SUBJECT: ISSUANCE OF AMENDMENT FOR INDIAN POINT NUCLEAR GENERATING UNIT NO. 3 RE: RADIOACTIVE EFFLUENT TECHNICAL SPECIFICATIONS (TAC NO. MA6225)

Amendment No. 199
License No. DPR-64

ATTACHMENT TO LICENSE AMENDMENT NO. 199

Information regarding radioactive gaseous and liquid effluents, which will allow identification of structures and release points as well as definition of UNRESTRICTED AREAS within the SITE BOUNDARY that are accessible to MEMBERS OF THE PUBLIC, shall be shown in Figure 4.7-1.

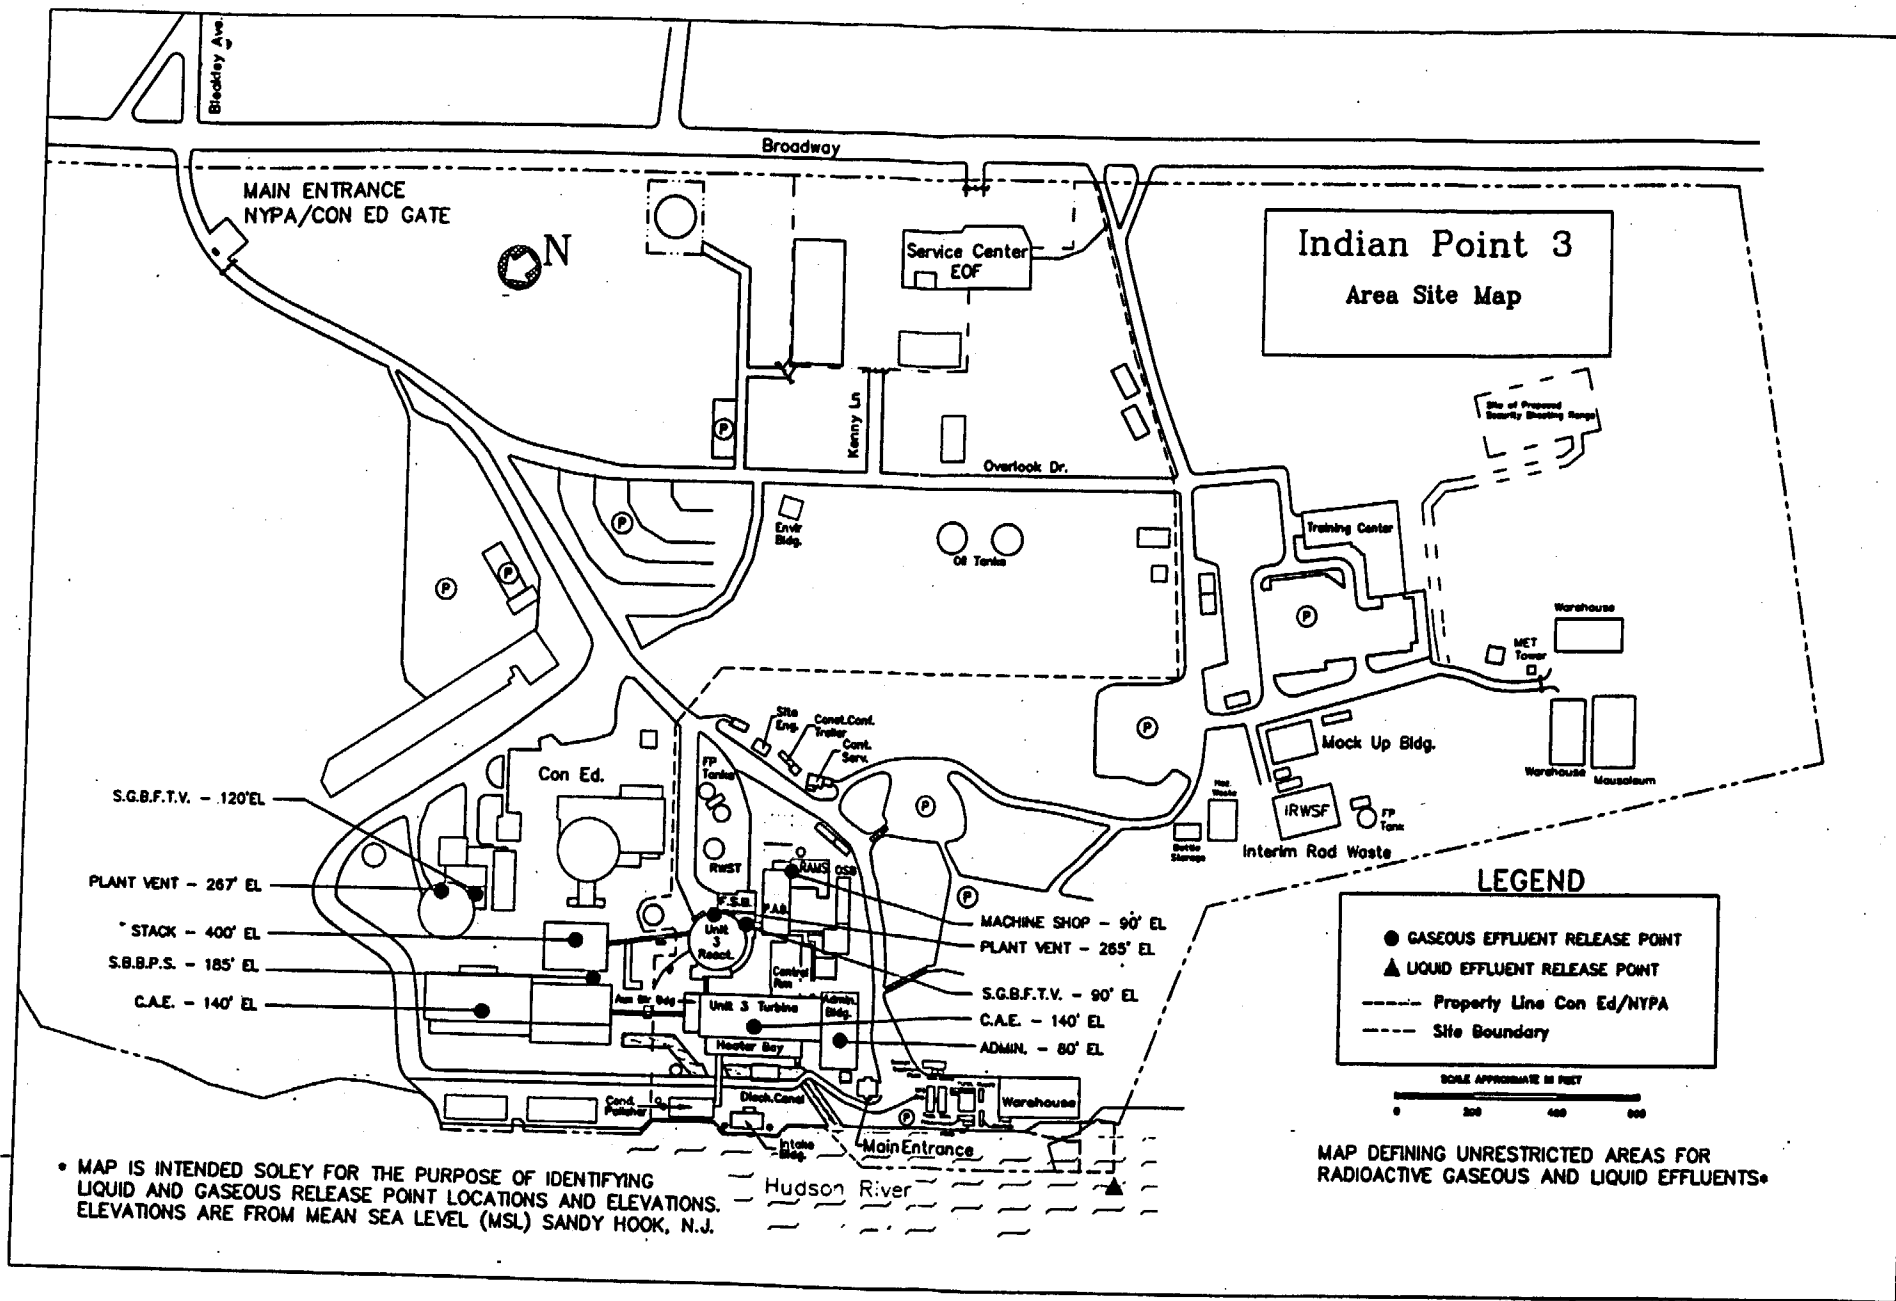
Part II of Appendix B, Technical Specification 5.8 and Figure 5.1-1 are being updated to reflect revised definitions and to reference the applicable Part 20 sections.
